# UNITED STATES PATENT AND TRADEMARK OFFICE

<b>Office Action Summary</b>	<b>Application No.</b> 10/765,499	<b>Applicant(s)</b> WOOD, CHARLES FRANCIS	
	<b>Examiner</b> Tan Le	<b>Art Unit</b> 3632

### **DETAILED ACTION**

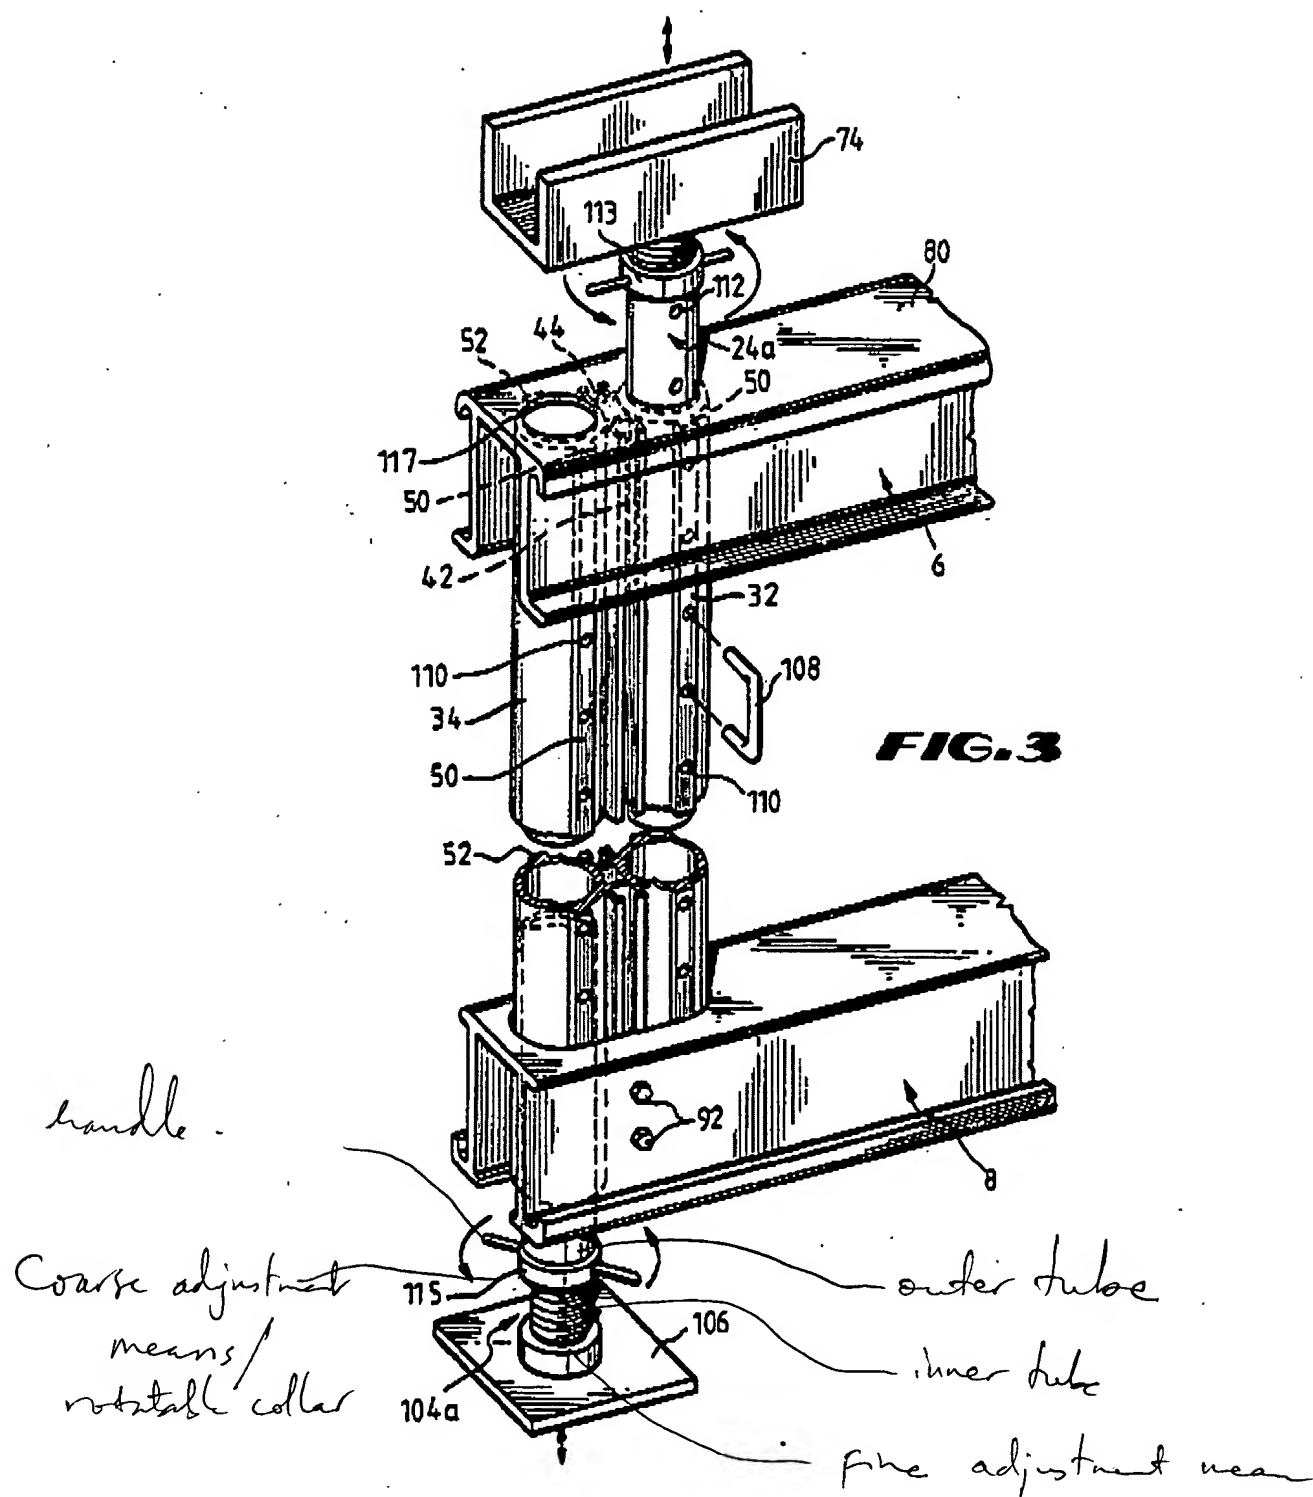
Claims 1-3 and 16 read on to Johnston as follows: Johnston teaches a post member (10), Fig. 3 or Fig. 4) comprising an inner tube (see marked-up copy); an outer tube slidably received within the outer tube, at least one of the inner tube and the outer tube being rotatable relative to the other; coarse adjustment means having a rotatable collar located at one end of the outer tube; and an affixing means for affixing the collar to the inner tube; and a fine adjustment means at one end of the post member comprising a threaded cylinder and a threaded receiver, wherein a selected of the threaded cylinder and threaded receiver is integral with a selected one of the outer and inner tubes, whereby rotation of the selected one of the outer tubes effects the fine adjustment.

As to claims 2-3, Johnston also teaches the adjustment means being located coaxially with a vertical axis of the inner and outer tubes and being located at a bottom of the post.

As to claim 16, Johnston also teaches a collar including a handle.
